T.I. no.: 2025-09 Updated: -	Topic: Replacement of retaining plate (3370067942)
---------------------------------	--

Date: 6/10/2025	Priority and need for action	
Affected machines: SOUL	<input type="checkbox"/> High: as soon as possible	
From production date: 12/1/2024	<input checked="" type="checkbox"/> Medium: next visit	<input checked="" type="checkbox"/> Medium: change in stock
From date: right away	<input type="checkbox"/> Low: FYI only

Retaining plate with welded bolt 3370067942, new and previous

Retaining bolt view, complete welded bolt 3370067942

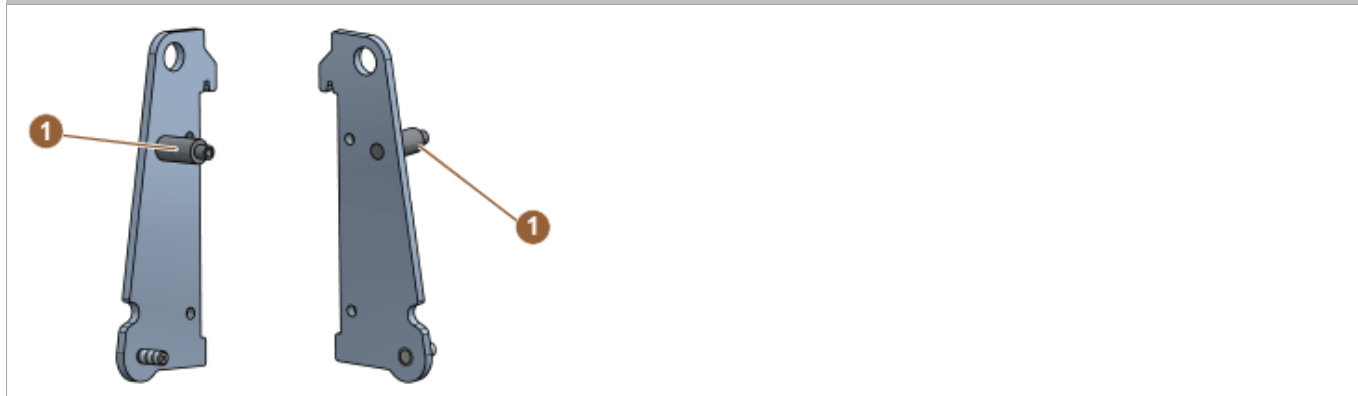
We have received feedback from the field that there have been problems with the 7-mm welded bolt (metal pin) for the retaining plate (article number 3370067942). The weld seam for the welded bolt is too weak, which means that the welded bolt can break off under excessive load. This causes problems when opening and closing the user panel.

Figure 1:
NEW: Retaining plate with reinforced weld seam.
The welded bolt remains stable.

Figure 2:
PREVIOUS: Retaining plate welded bolt, with weaker weld seam.
The welded bolt can rip out.

The welding process has since been corrected and optimized. The weld seam has been reinforced to ensure the stability of the welded bolt.

- ▶ Replace the retaining plate.

- ▶ Check the stock levels and replace with the new retaining plate if necessary.
